ENGINE - ELECTRICAL POWER - REVISED IDG OIL COOLER WITHOUT OIL INLET THERMOCOUPLE PORT
- CATEGORY CODE 7. ACCOMPLISH WHEN SUPPLY OF SUPERSEDED PARTS HAS BEEN DEPLETED -
MOD.ENG-24-0002

V2500-ENG-24-0002

SERVICE BULLETIN No. 11844-001

INTEGRATED DRIVE GENERATOR (IDG) SYSTEM - INTRODUCTION OF A NEW FUEL COOLED IDG OIL COOLER

Fuel Cooled IDG Oil Cooler - Before and After Alteration
Figure 1

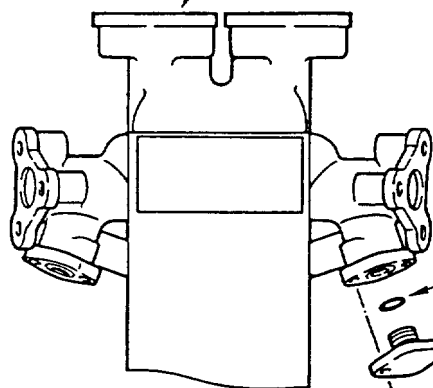
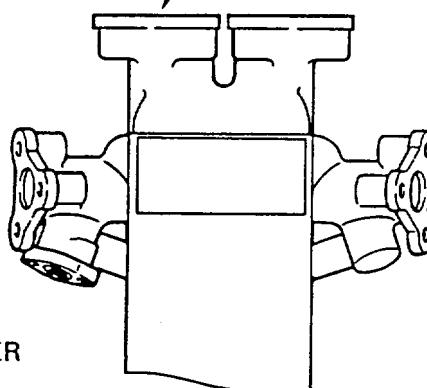
Potential oil leakage of the Fuel Cooled IDG Oil Cooler through the blanking for oil inlet thermocouple port.

A design review for the existing Fuel Cooled IDG Oil Cooler suggested an elimination of the unnecessary oil inlet thermocouple flange and port.

- (a) A new Fuel Cooled IDG Oil Cooler without oil inlet thermocouple flange and port has been introduced (See Figure 1).
- (b) The existing Bolts, Sealing Ring and Cover which are used to blank off the oil inlet thermocouple port have been deleted (See Figure 1).

- (1) Install 5L0033 (15844-000) Fuel Cooled IDG Oil Cooler, to the engine by the approved procedures in the Engine Manual, 72-00-32, Installation.

Fuel Cooled IDG Oil Cooler - Before and After Alteration
Figure 1

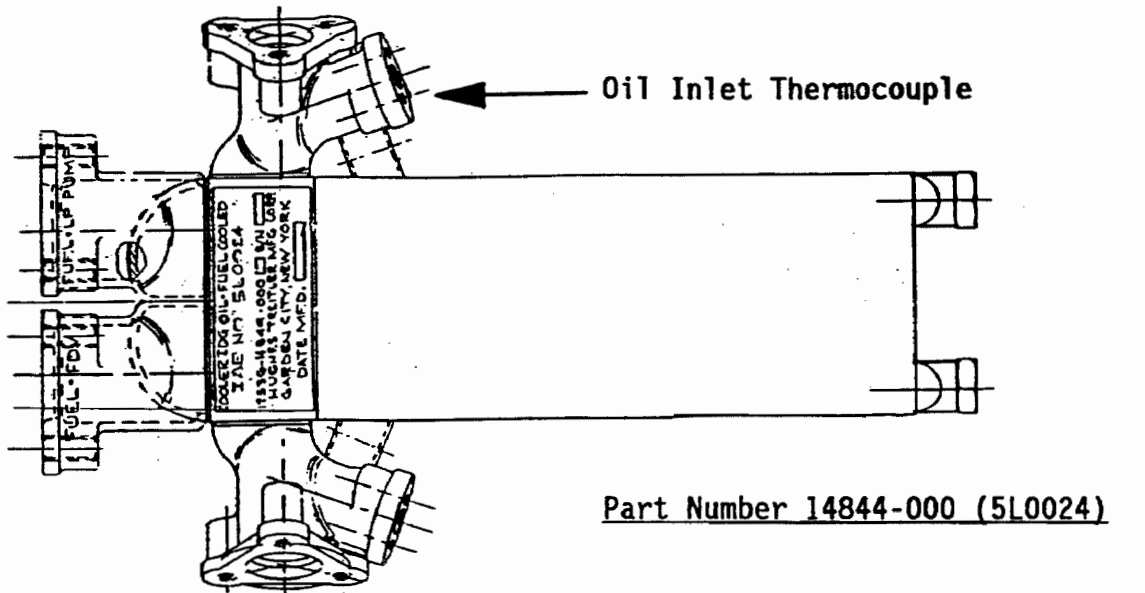
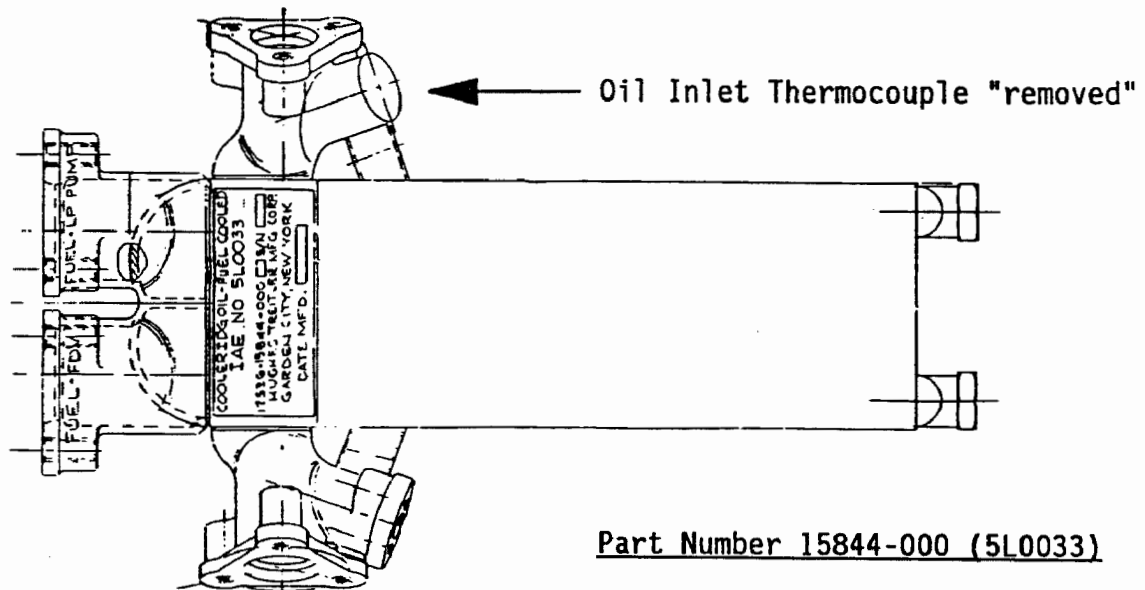
This Service Bulletin introduces a new Fuel Cooled IDG Oil Cooler without Oil Inlet Thermocouple Flange and Port.

- (a) The Thermocouple Flange and Port on Oil Inlet Casting are removed from the Fuel Cooled IDG Oil Cooler (see Figure 1).
